Communication from Public

Council File No: 25-0181

Site Accessibility Evaluation

**L. Ron Hubbard Way to N.
Catalina Street
East Hollywood, CA 90027**

Finding: 1

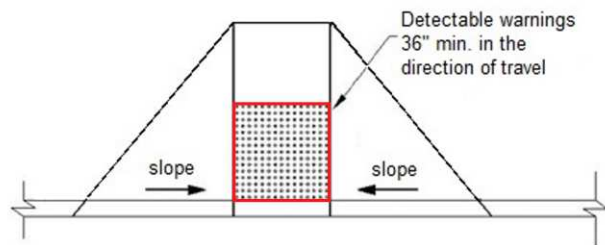
Detectable warnings at curb ramps shall extend the full width of the curb ramp excluding any flared side and 36 inches in the direction of travel.

Detectable warnings shall extend the full width of the turning space at the flush transition between the street and the sidewalk less 2 inches maximum on each side.

2022 CBC 11B Section 11B-705.1.2.2

Finding: 2

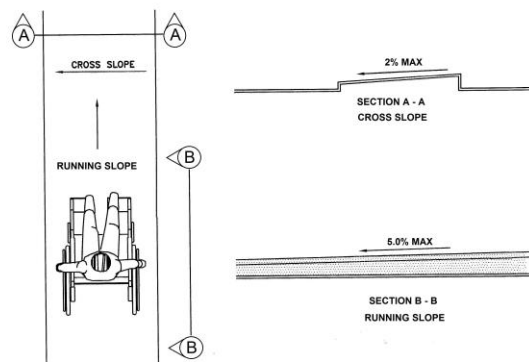
The accessible path of travel has cross slopes greater than 2%.

Surface cross slopes shall not exceed one unit vertical in 48 units horizontal (2-percent slope). When the slope in the direction of travel of any walk exceeds 1 unit vertical in 20 units horizontal (5-percent slope), it must be constructed as a ramp.

2010 ADAS Section 403.3

Finding: 5

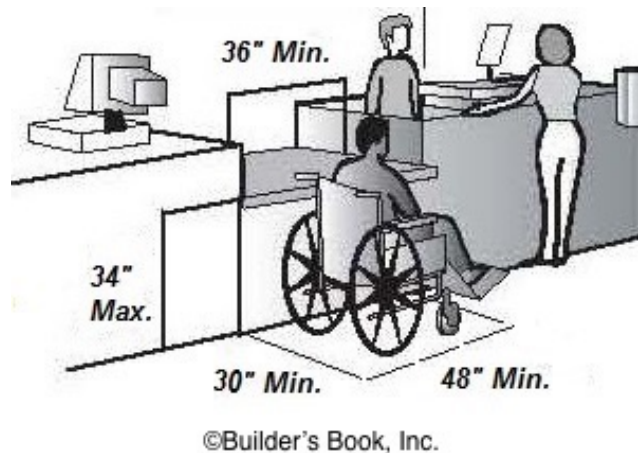
The transaction counter provides for a parallel approach and is not within the required height range.

Transaction counters shall be 28 to 34 inches high and a minimum of 36 inches wide and should extend the same depth as the sales or service counter tops.

2022 CBC 11B Section 11B-904.4.1

Finding: 6

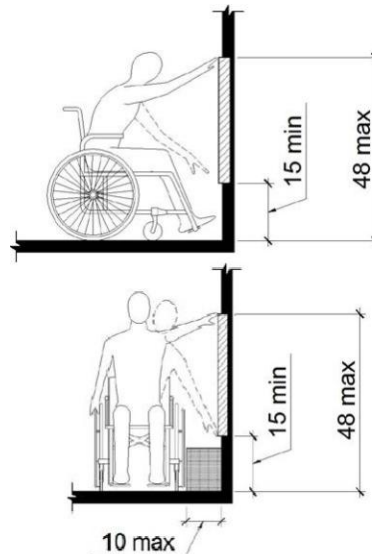
The order and receiving food window is positioned too high for either a side or front approach.

Where a clear floor or ground space allows a parallel approach to an element and the side reach is unobstructed, the high side reach shall be 48 inches maximum and the low side reach shall be 15 inches minimum above the finish floor or ground.

Where a forward reach is unobstructed, the high forward reach shall be 48 inches maximum and the low forward reach shall be 15 inches minimum above the finish floor or ground.

Finding: 8

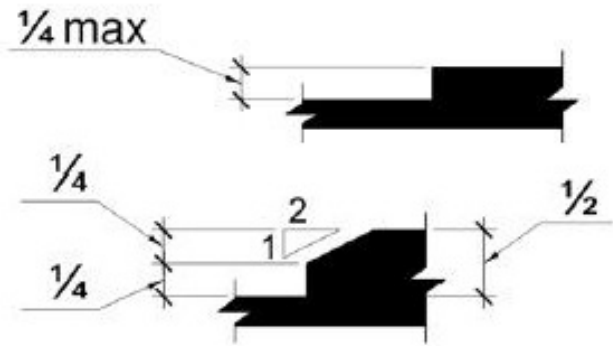
The walkway contains abrupt vertical edges and/or variations over 1/4 inch.

1/4 inch is the maximum vertical rise. Changes in level between 1/4 inch and 1/2 inch must be beveled at 1:2 or less.

Changes in level greater than 1/2 inch must be by way of a ramp.

Finding: 9

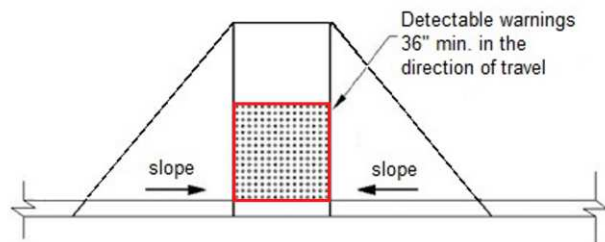
Detectable warnings at curb ramps shall extend the full width of the curb ramp excluding any flared side and 36 inches in the direction of travel.

Detectable warnings shall extend the full width of the turning space at the flush transition between the street and the sidewalk less 2 inches maximum on each side.

2022 CBC 11B Section 11B-705.1.2.2

Finding: 10

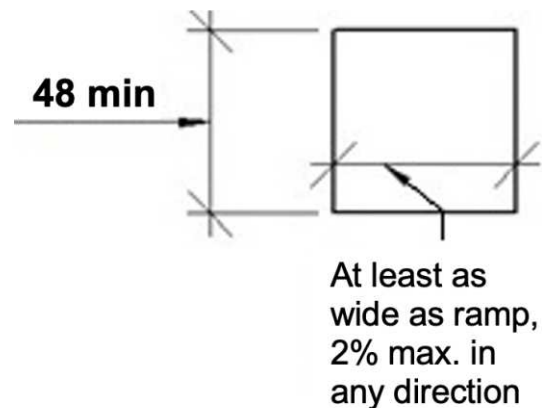
The top landing for the curb ramp is not level and exceeds a 2% slope.

A level landing 48 inches long shall be provided at the upper end of each curb ramp over its full width to permit safe egress from the ramp surface. The slope of the landing in all directions shall be 1:48 maximum.

2022 CBC 11B Section 11B-406.5.3

Finding: 11

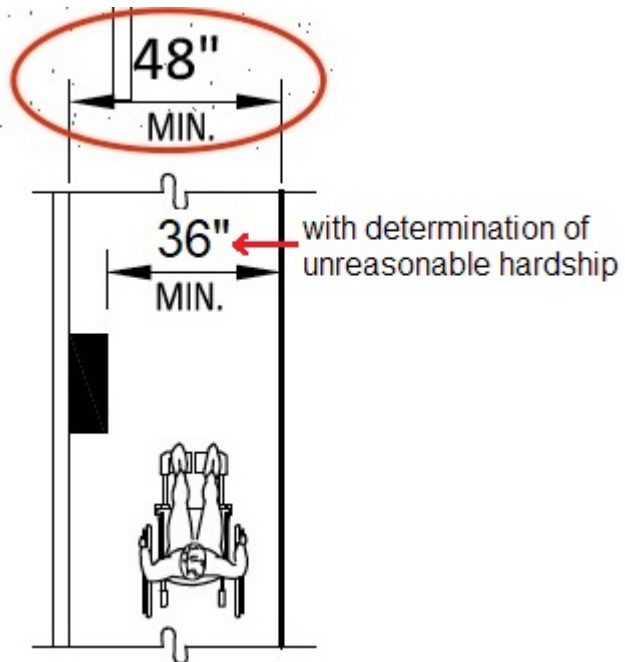
The route of travel does not provide the required minimum width.

The minimum clear width for sidewalks and walks is 48 inches.

2022 CBC 11B Section 11B-403.5.1 Exceptions: 3

Planter boxes have been installed on the entire sidewalk without a path of travel between them to cross the street or to be dropped off. Suggest new vegetation with 6" max. height with city permit.

Finding: 17

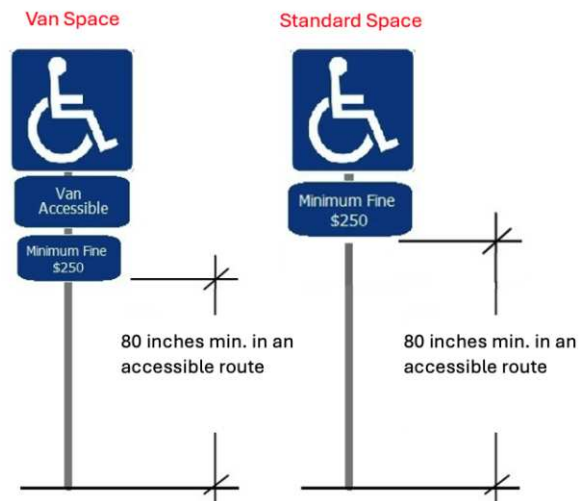
The sign is mounted too low.

Signs located within an accessible route shall be a minimum of 80 inches above the finish floor or ground surface measured to the bottom of the sign.

2022 CBC 11B Section 11B-502.6

Finding: 18

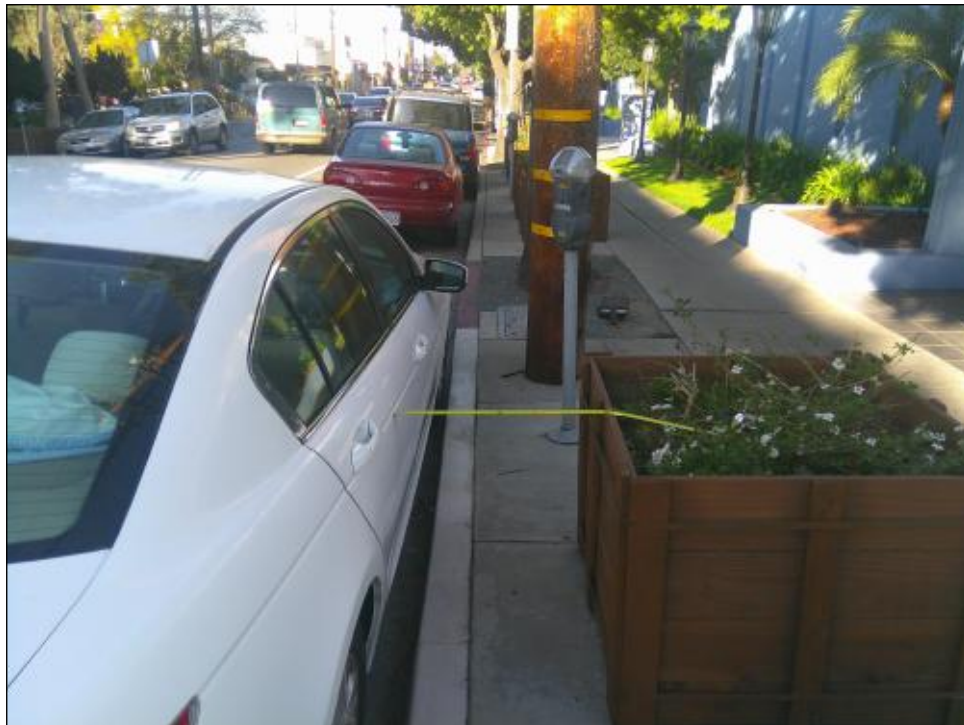
The planter boxes are too high, and too close to the city curb. People with and without disabilities struggle to open their doors and exit their cars. Additionally, there is not a 48" min. path of travel between the boxes.

Finding: 19

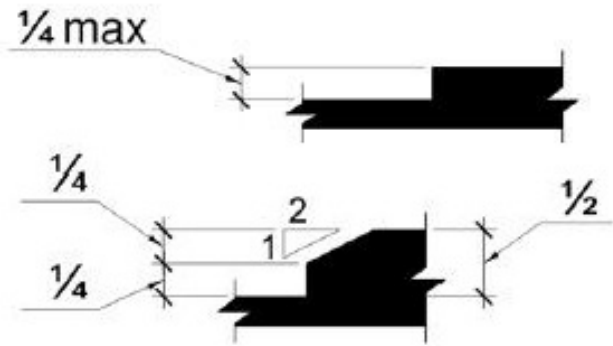
The walkway contains abrupt vertical edges and/or variations over 1/4 inch.

1/4 inch is the maximum vertical rise. Changes in level between 1/4 inch and 1/2 inch must be beveled at 1:2 or less.

Changes in level greater than 1/2 inch must be by way of a ramp.

Finding: 21

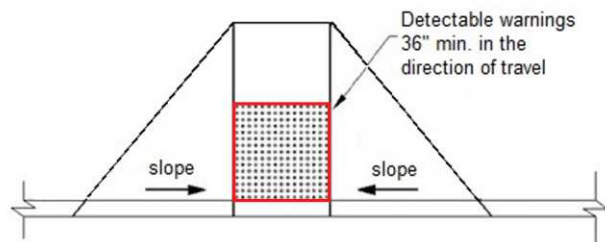
Detectable warnings at curb ramps shall extend the full width of the curb ramp excluding any flared side and 36 inches in the direction of travel.

Detectable warnings shall extend the full width of the turning space at the flush transition between the street and the sidewalk less 2 inches maximum on each side.

2022 CBC 11B Section 11B-705.1.2.2

Finding: 23

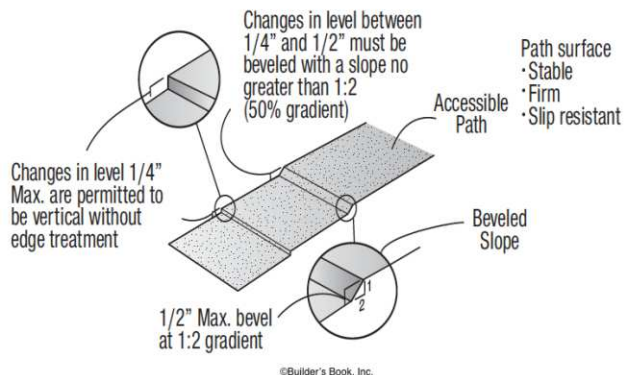
The accessible route contains loose vegetation and/or surface materials that do not provide for a stable, firm slip resistant surface.

Floor and ground surfaces shall be stable, firm, and slip resistant.

2022 CBC 11B Section 11B-302.1

Suggest installing a firm path of travel for persons with disabilities that operate vehicles since the adjacent site is private parking. Additionally, suggest a different type of plant other than a thorny rose bush that makes it difficult for persons with or without disabilities.

Finding: 24

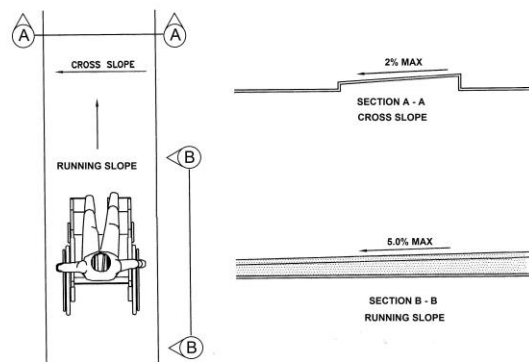
The accessible path of travel has cross slopes greater than 2%.

Surface cross slopes shall not exceed one unit vertical in 48 units horizontal (2-percent slope). When the slope in the direction of travel of any walk exceeds 1 unit vertical in 20 units horizontal (5-percent slope), it must be constructed as a ramp.

2010 ADAS Section 403.3

Finding: 25

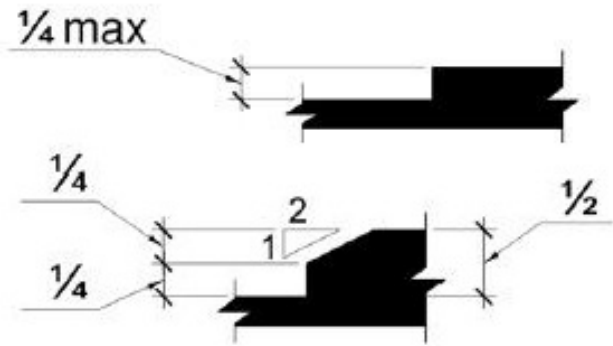
The walkway contains abrupt vertical edges and/or variations over 1/4 inch.

1/4 inch is the maximum vertical rise. Changes in level between 1/4 inch and 1/2 inch must be beveled at 1:2 or less.

Changes in level greater than 1/2 inch must be by way of a ramp.

Finding: 27

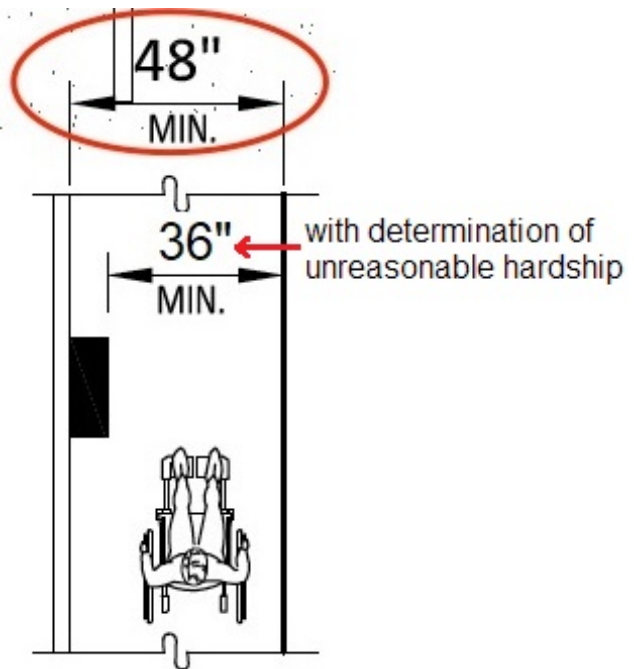
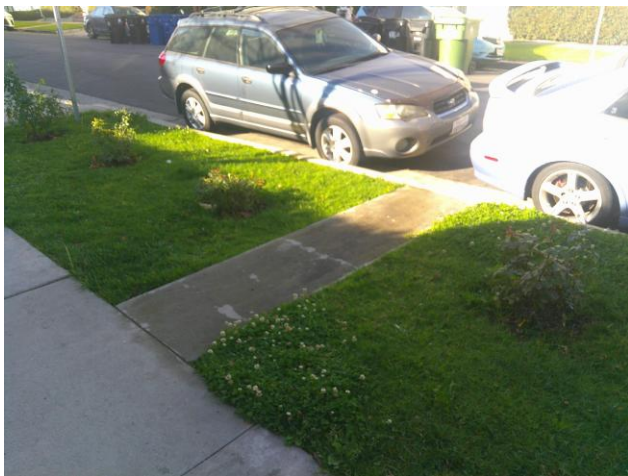
The route of travel does not provide the required minimum width.

The minimum clear width for sidewalks and walks is 48 inches.

2022 CBC 11B Section 11B-403.5.1 Exceptions: 3
